City of Nedlands

Agenda

Council Meeting 23 March 2021

PRINCIPLE 6 - Amenity

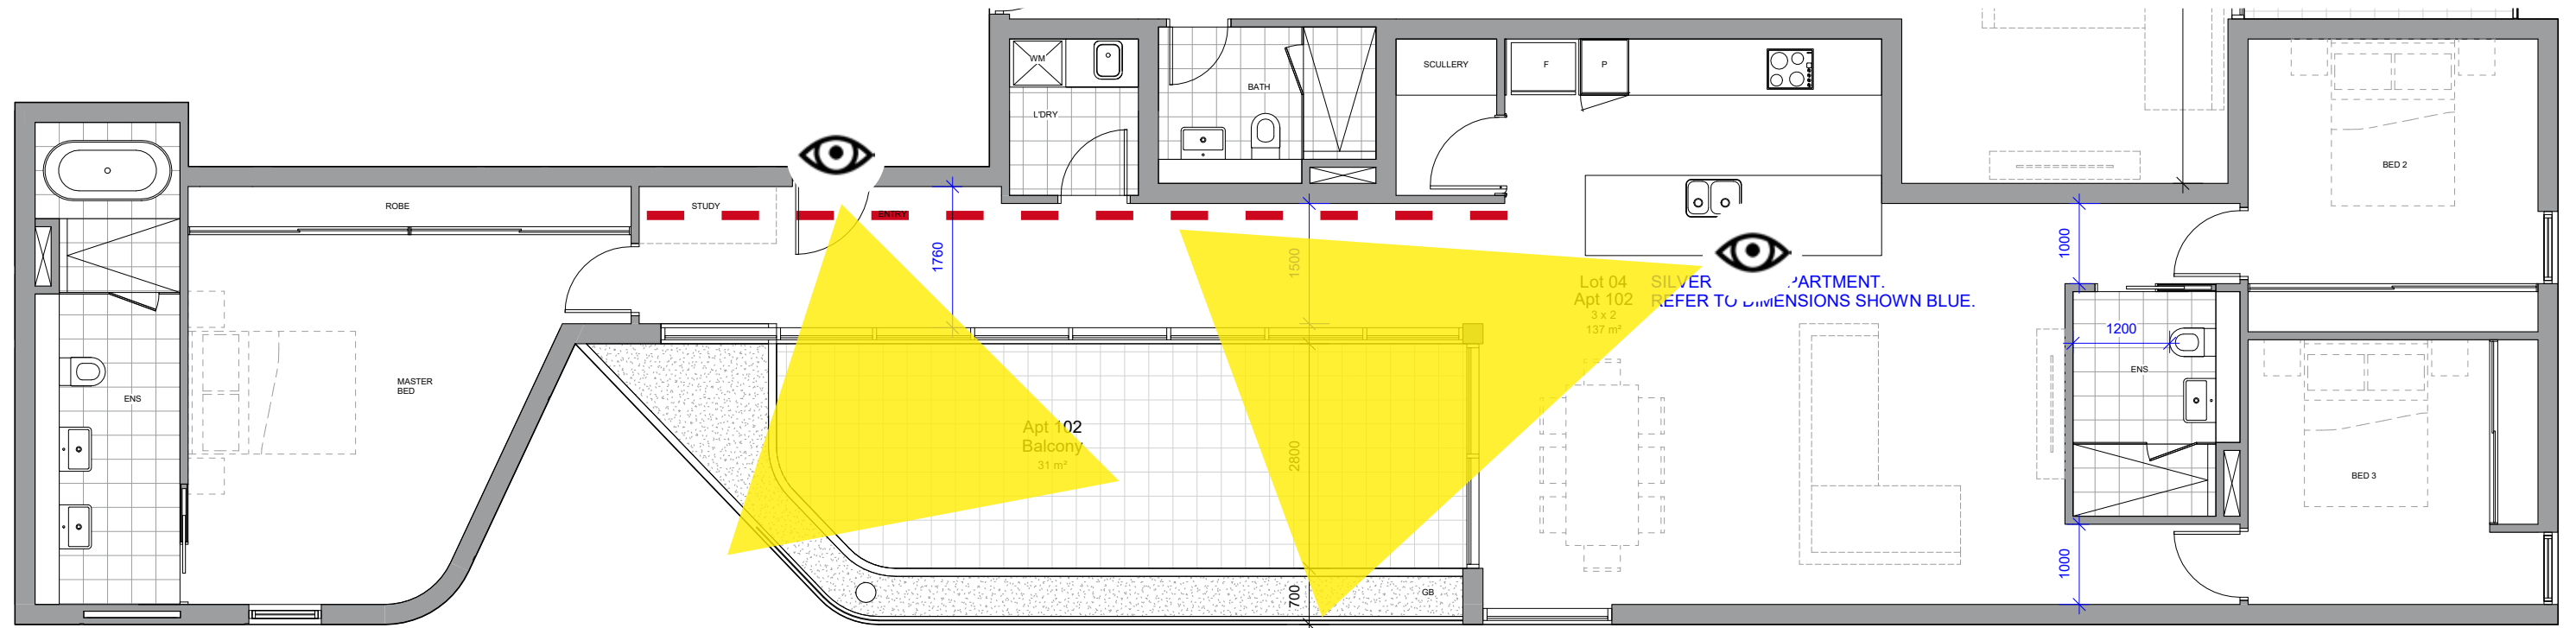
“Comments was made in the design presentation regarding the planning around long apartment on the western flank. The corridor length and planning around the entrance and balcony may be better resolved.”

PRINCIPLE 8 - Safety

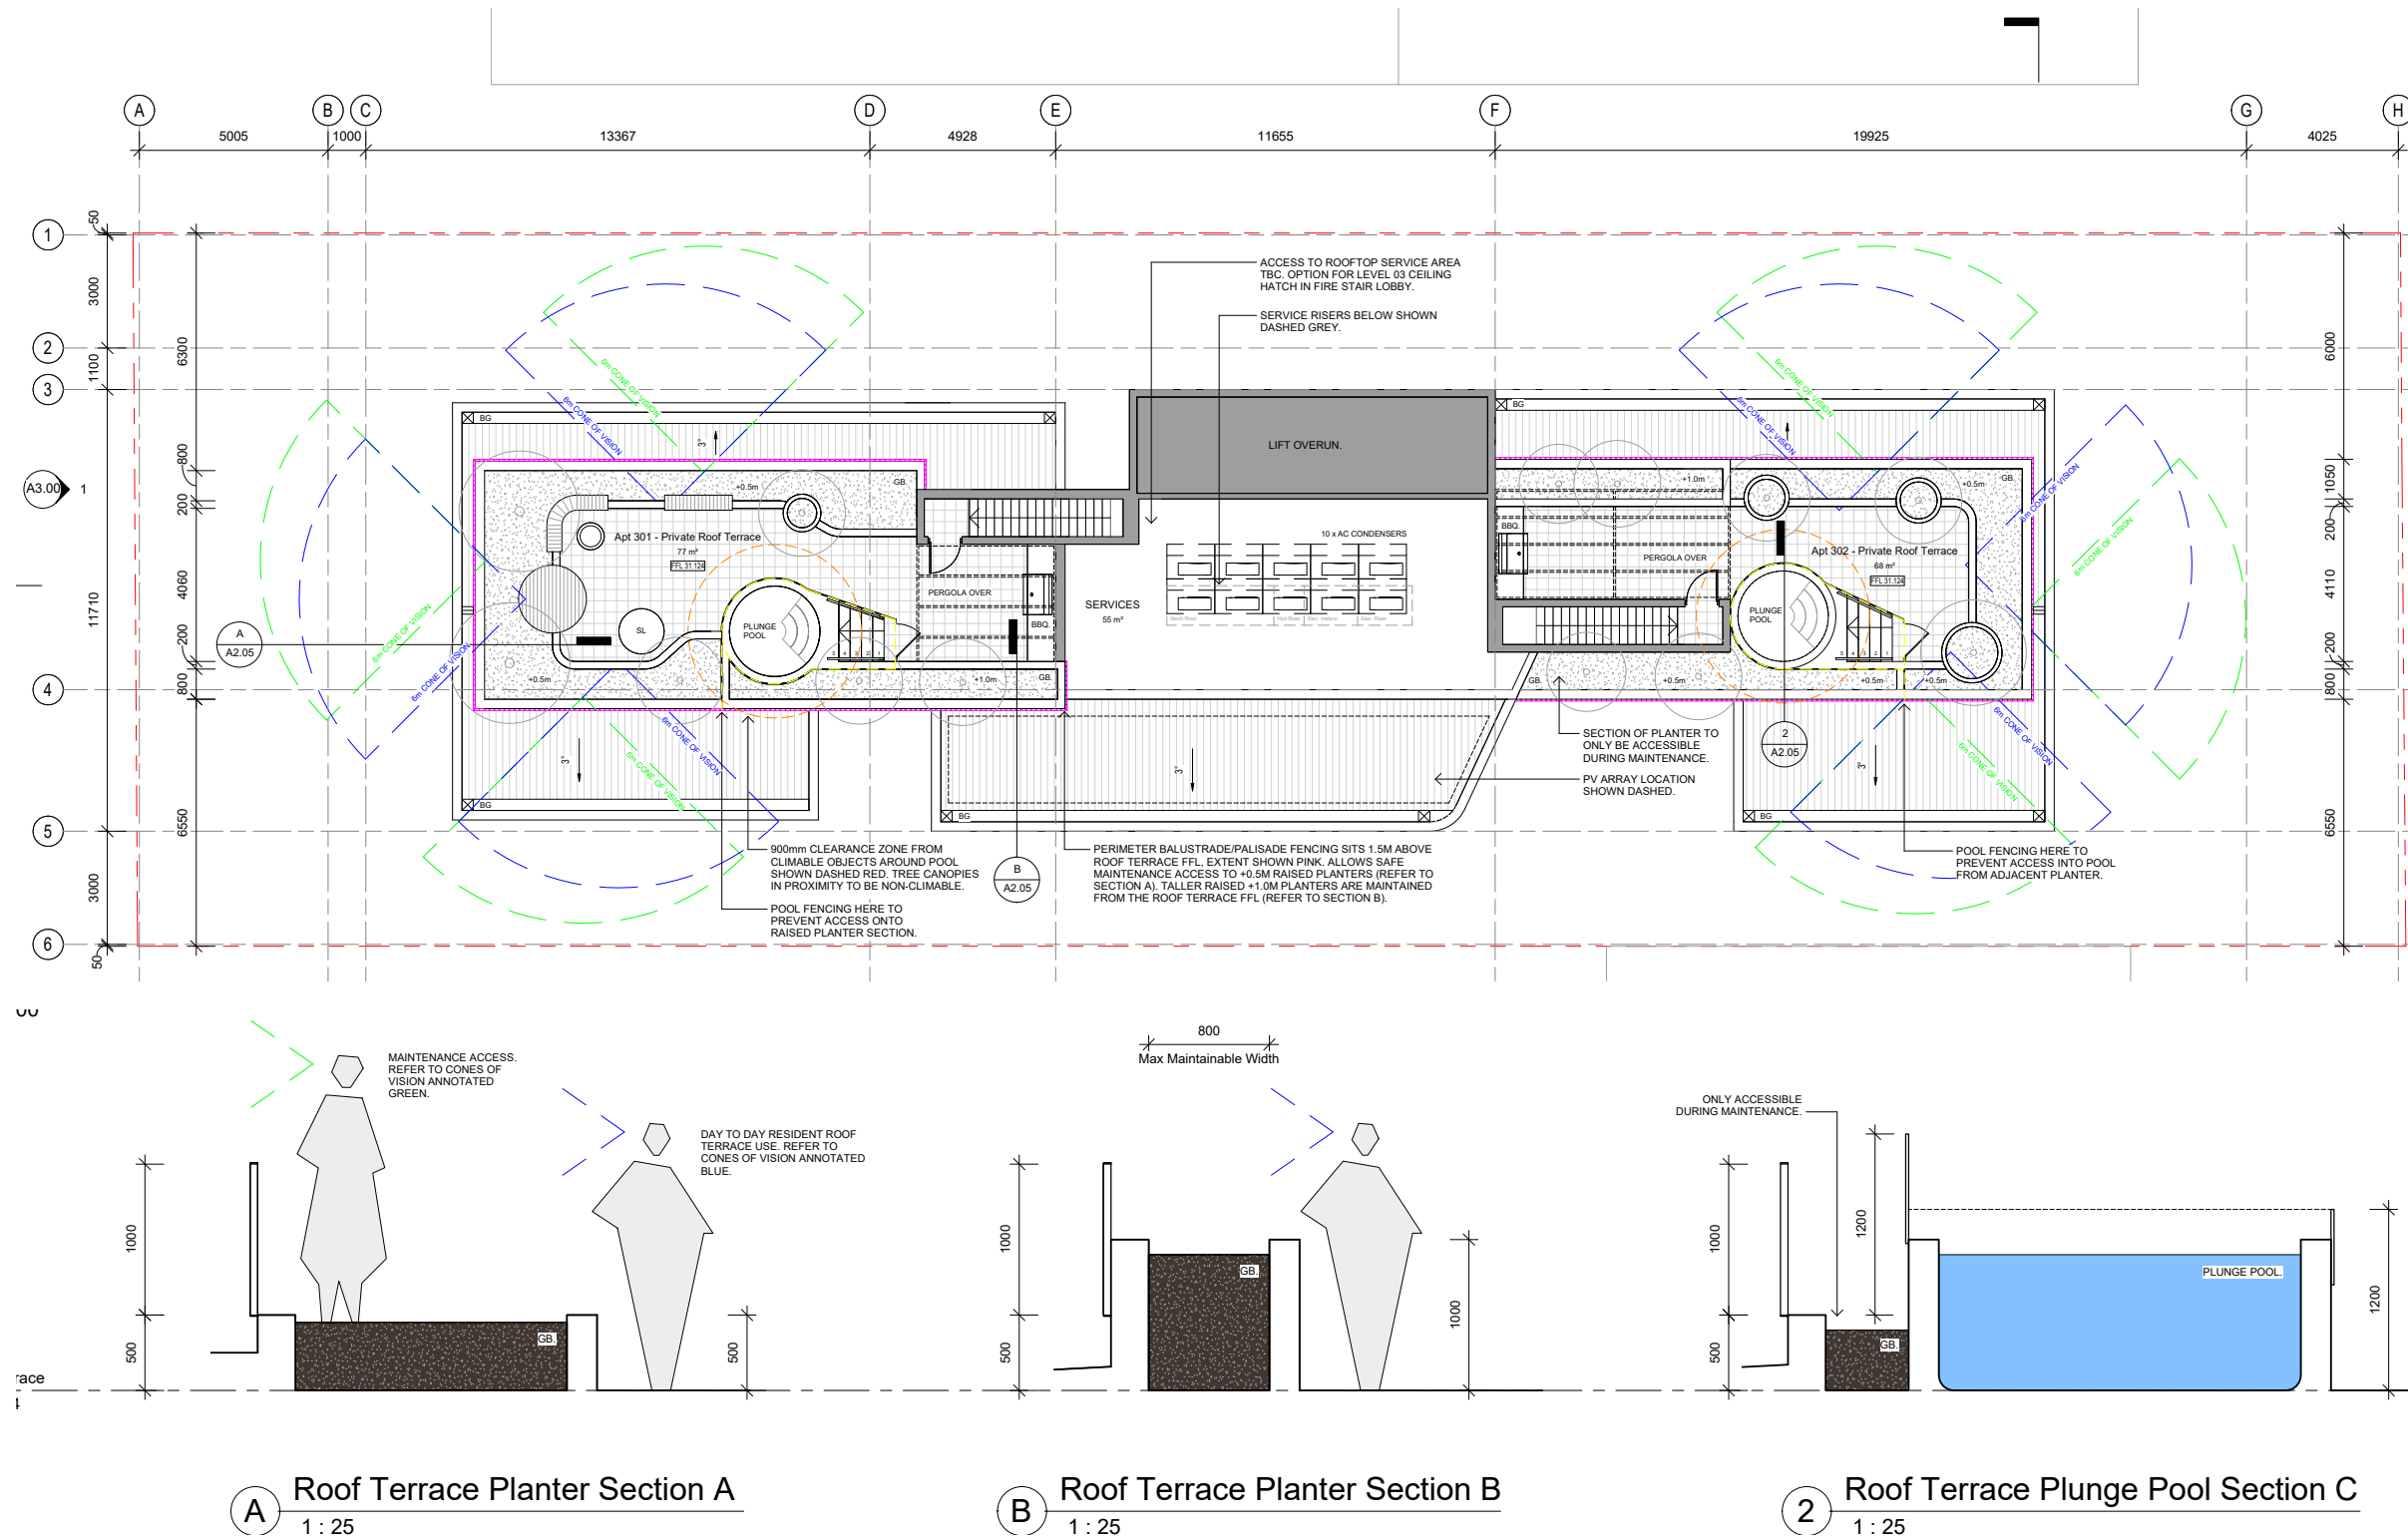
“Please re-consider the appropriateness and safety measures around the resident’s roof garden and amenity, in particular the plunge pool.”
